ADDENDUM

NO. 01

PROJECT NAME: Littleton Springs Elementary School

ADDENDUM DATE: March 13, 2026

01 FINISH PLAN - AREA B - LEVEL 02
1/8" = 1'-0"

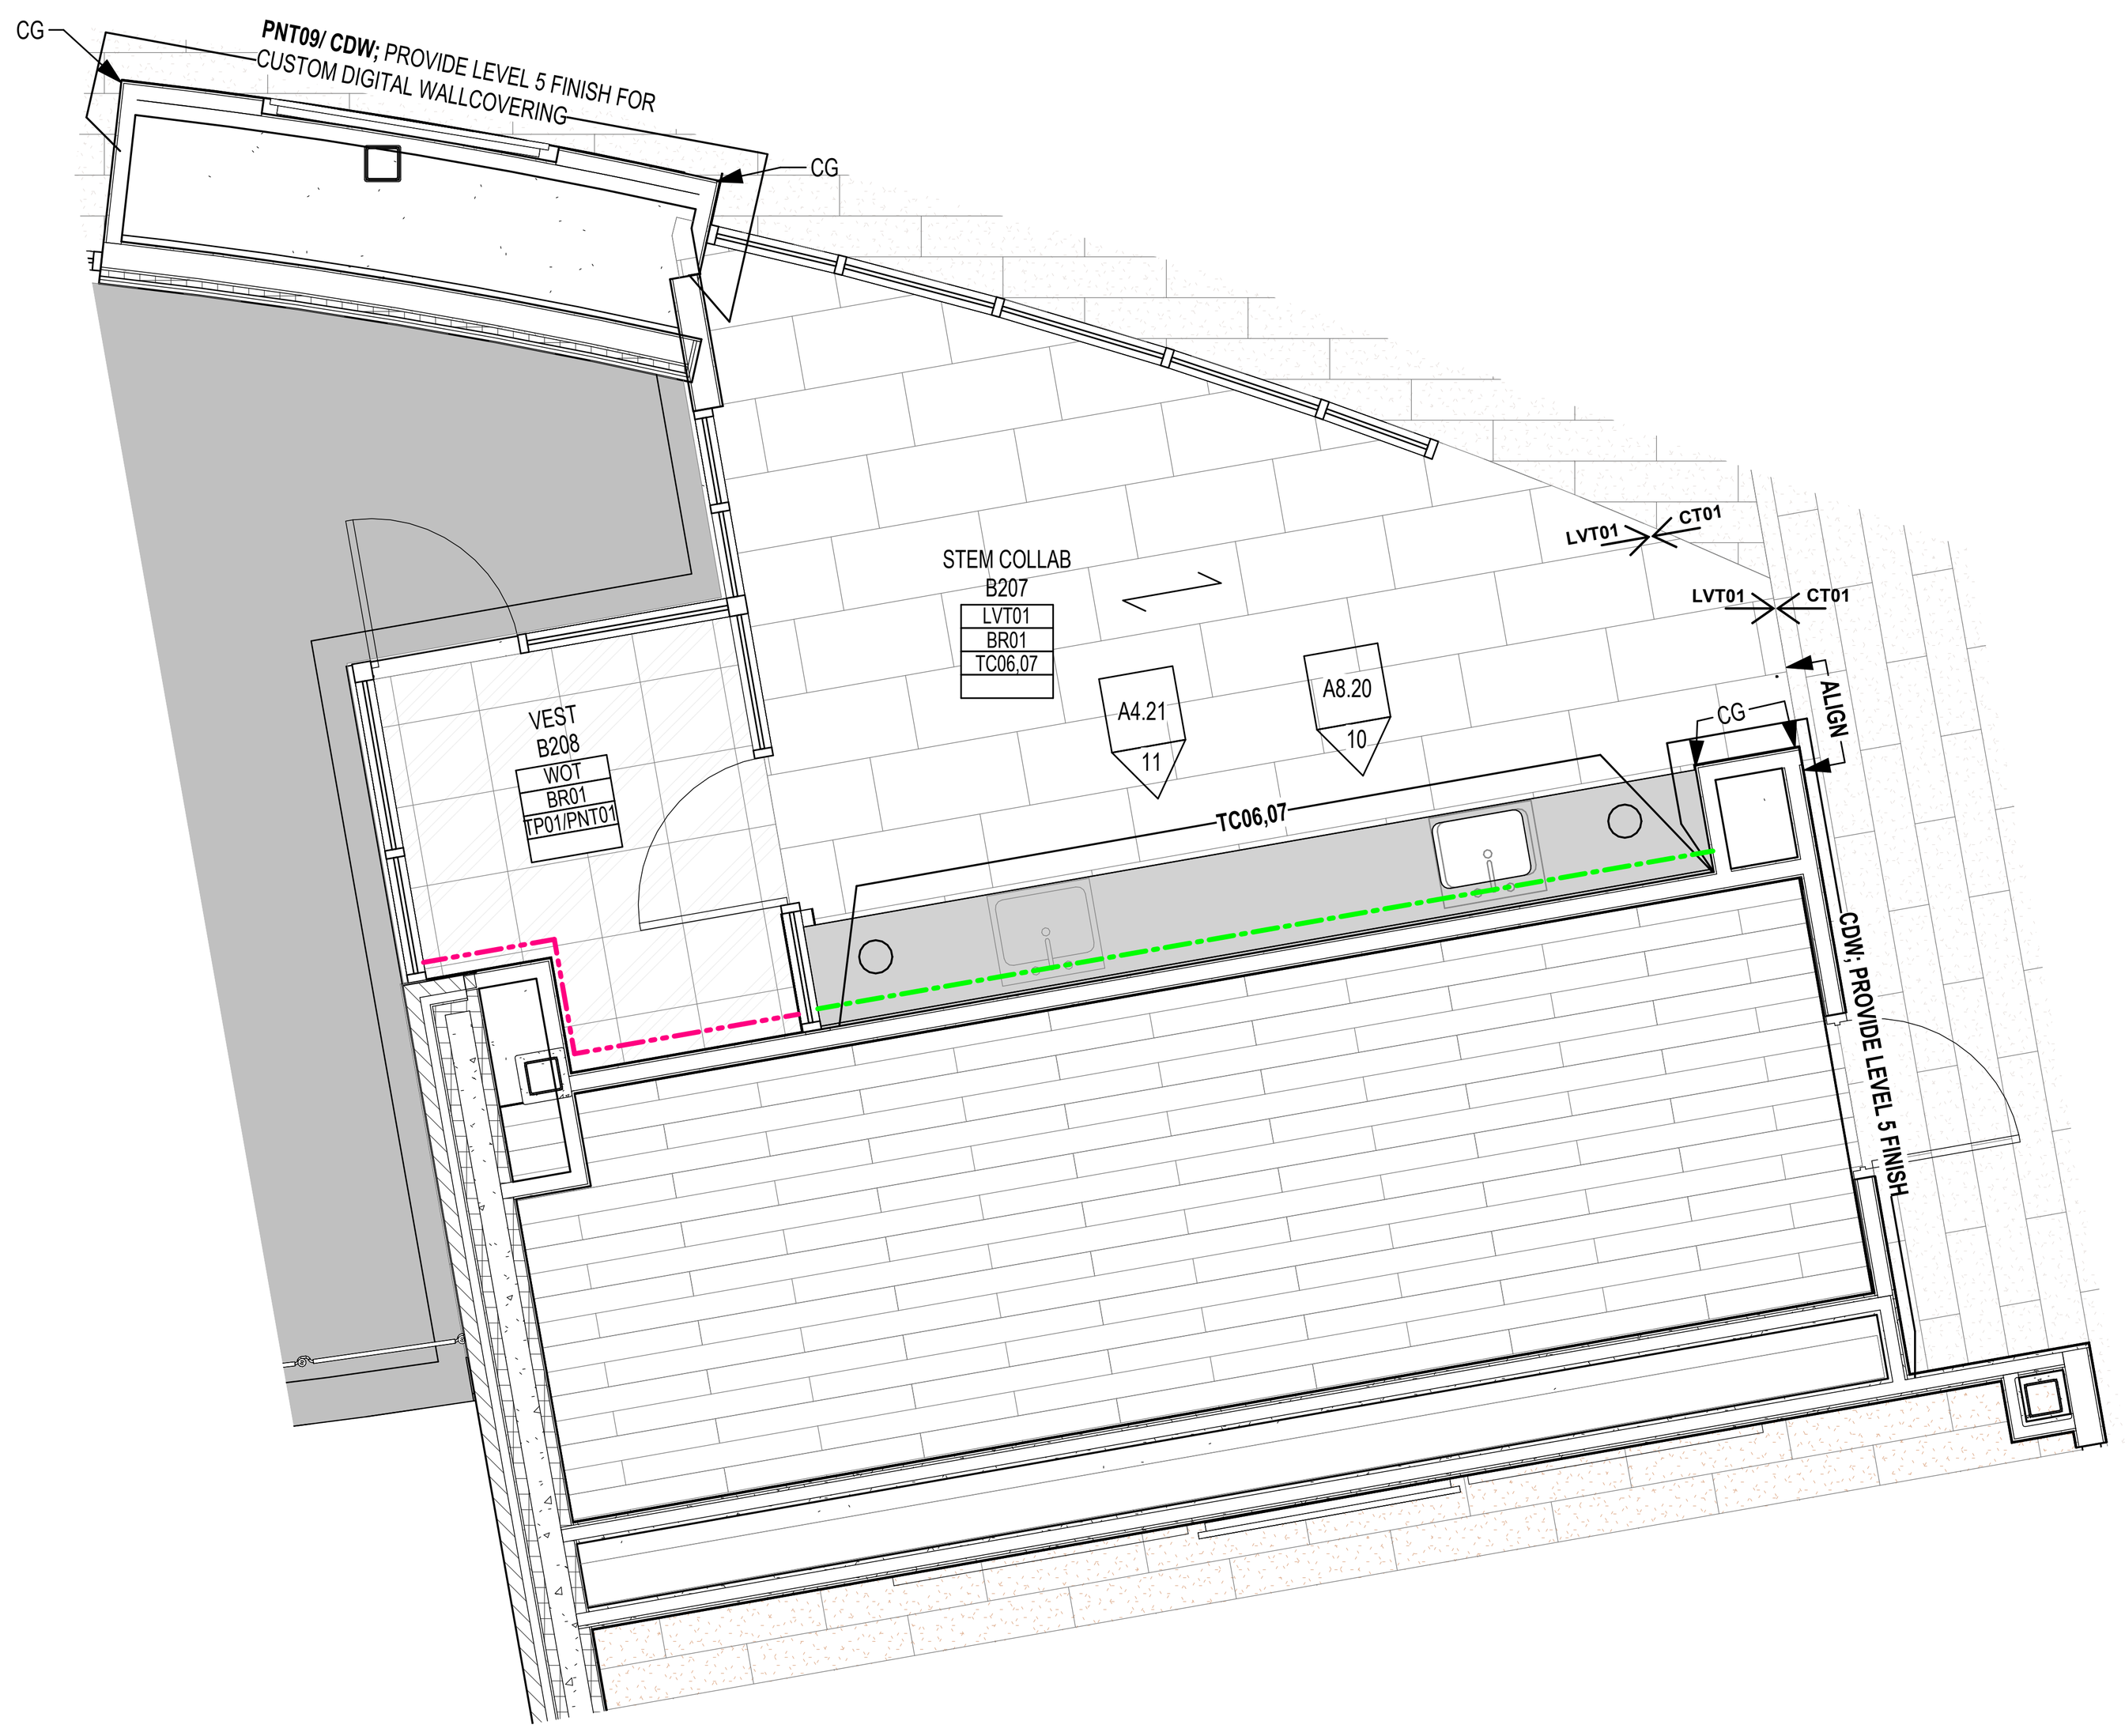
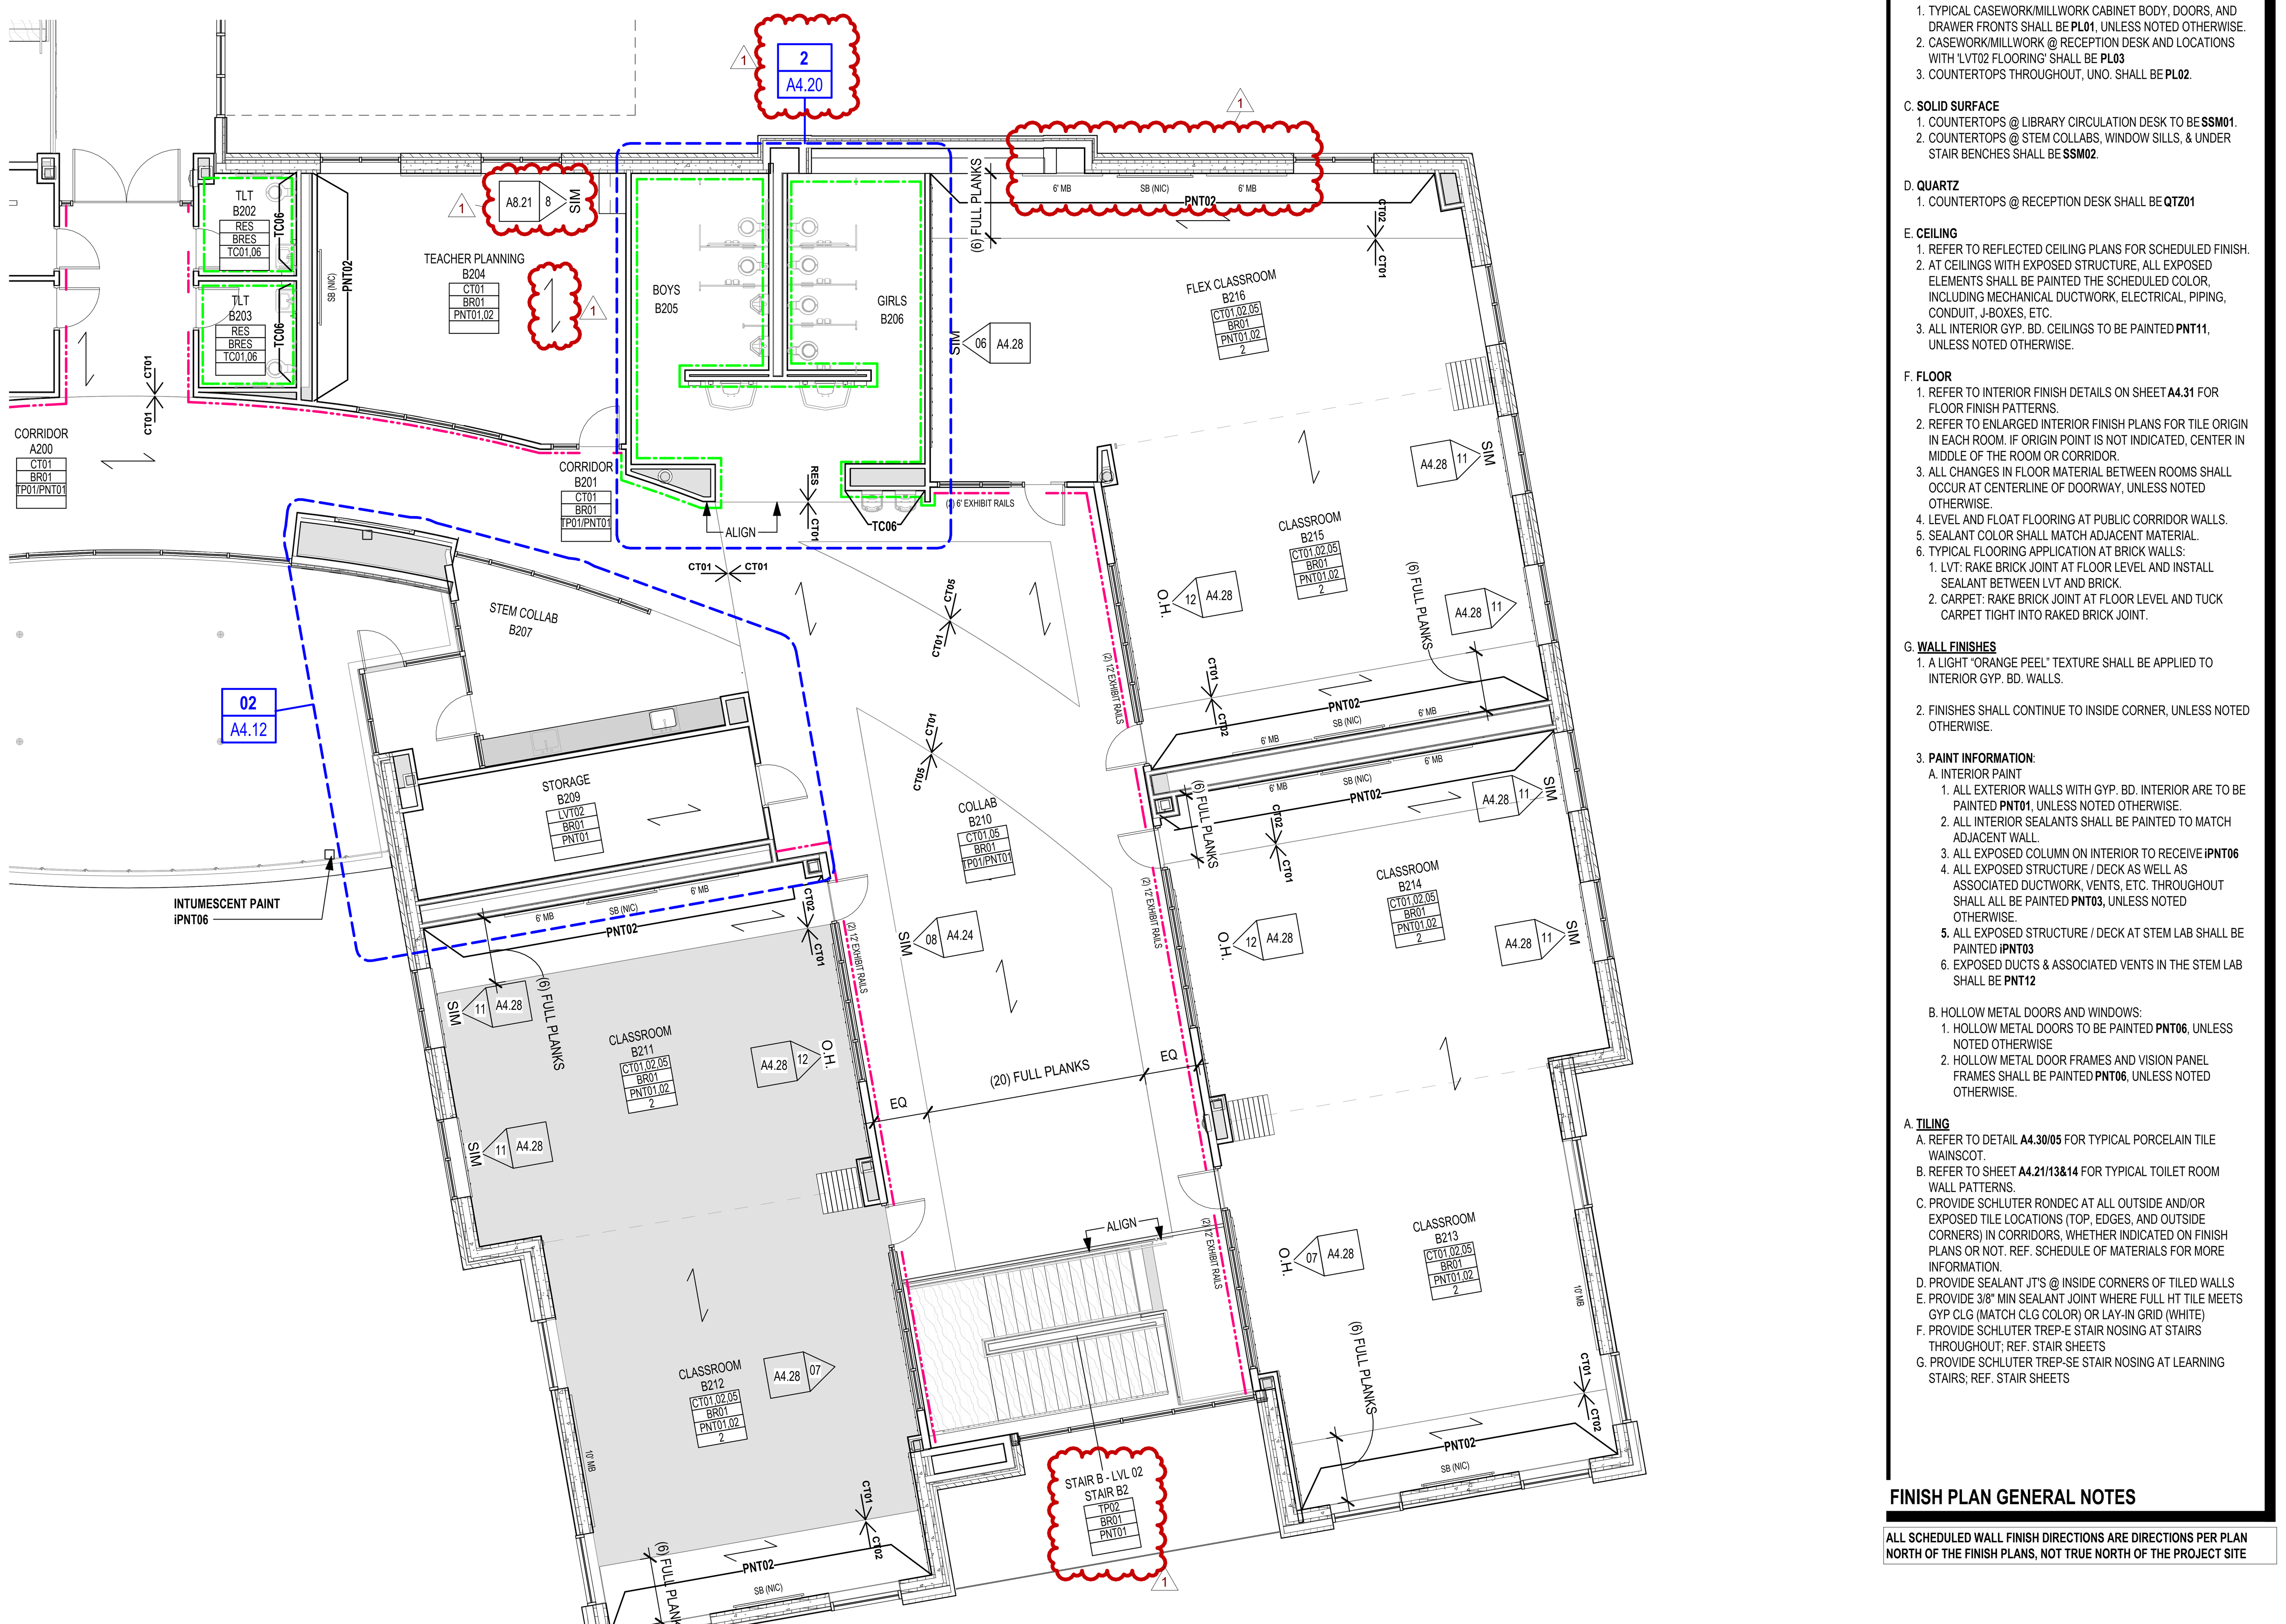
P2ADD 01, Arch Item 28: To the Drawings, Sheet A4.12, "FINISH PLAN – AREA B – LEVEL 02"

1) Update the extent of the enlarged stem collab plan to show entire location of wall graphics and corner guards.
2) Provide callout 02/A4.20 for group toilets for clarification.
3) Adjust teaching wall in flex classroom north that was missing a 6'TB.
4) Add missing reference casework elevation for casework in teacher planning & changed flooring direction.
5) Update Stair B2 finish tag. Intent is for stair treads and risers to be TP02.

01 FINISH PLAN - AREA D - LEVEL 02
1/8" = 1'-0"

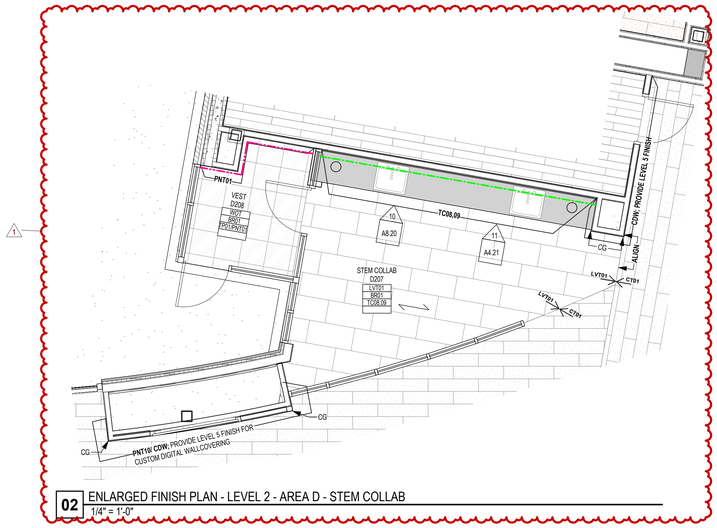
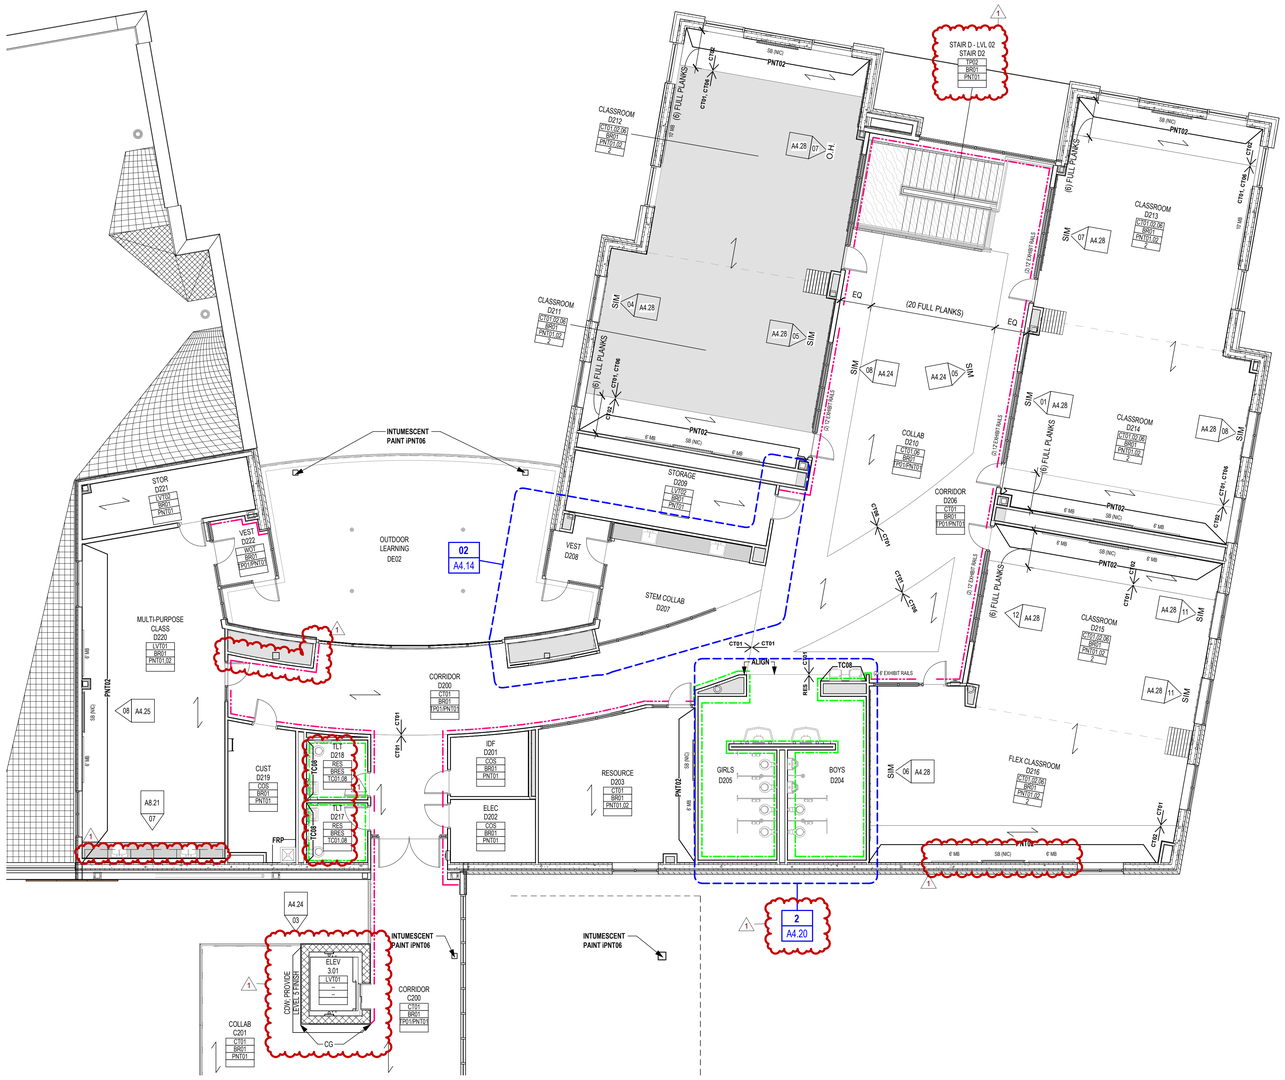
P2ADD 01, Arch Item 29: To the Drawings, Sheet A4.14, "FINISH PLAN – AREA D – LEVEL 02"

1) Update the extent of the enlarged stem collab plan to show entire location of wall graphics and corner guards.
2) Provide callout 02/A4.20 for group toilets for clarification.
3) Add upper cabinets in Multi-purpose classroom.
4) Update Stair D2 finish tag. Intent is for stair treads and risers to be TP02.
5) Update teaching wall in flex CR D216.
6) Update room finish tag in single use toilets.
7) Update location missing tile wainscot.
8) Provide annotations for clarity at elevator.

Job No. 1974-03-01	Sheet No. A4.26
Drawn By: AT, MB	
Date: 03/02/2026

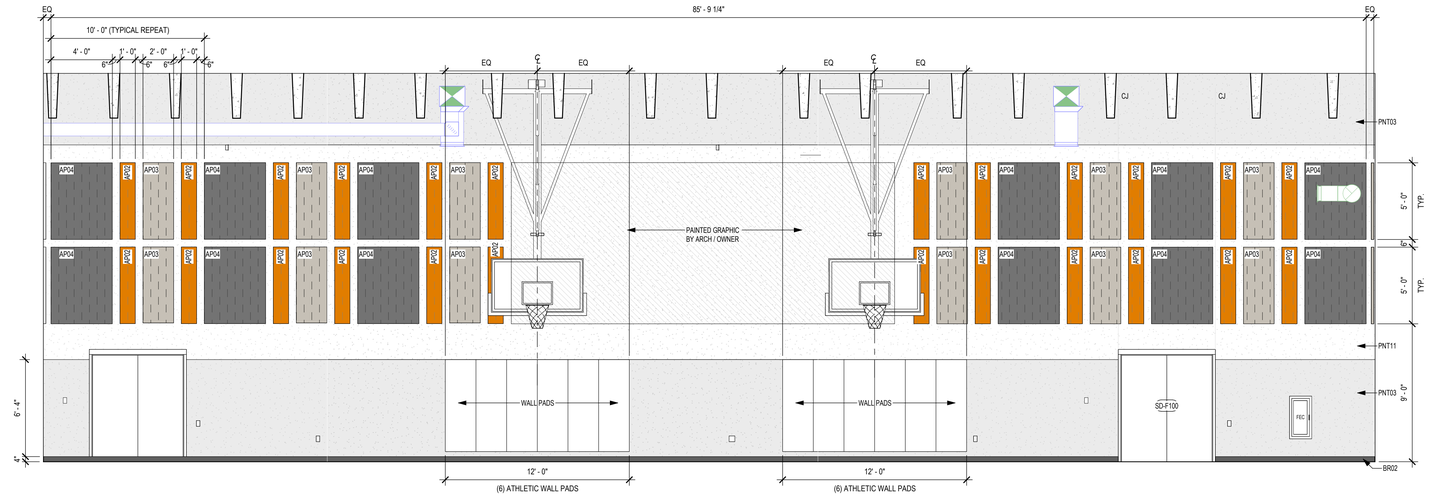
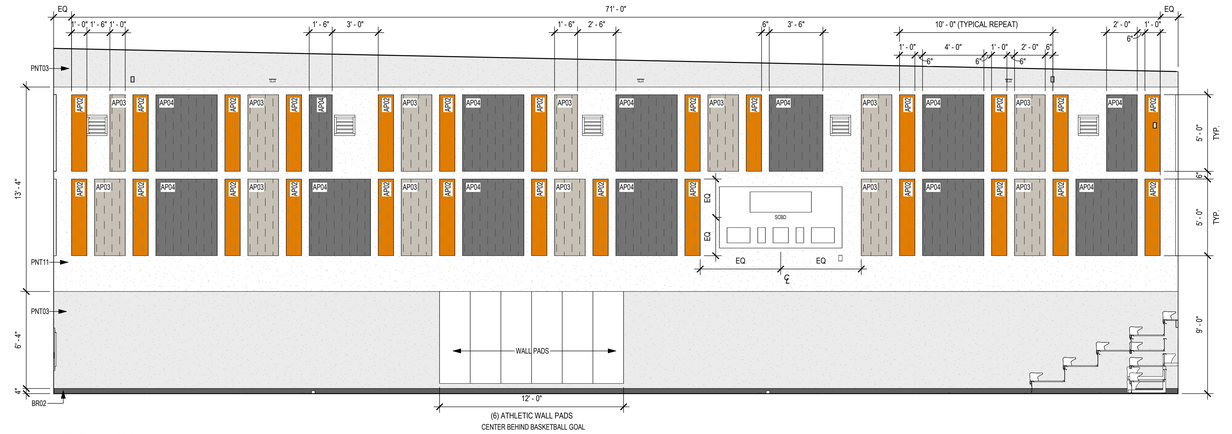
P2ADD 01, Arch Item 34: To the Drawings, Sheet A4.25, "INTERIOR ELEVATIONS"

1) Remove 'vertical alignment' annotation on 05/A4.25; changed tackrail callouts to (2) 6' exhibit rails.
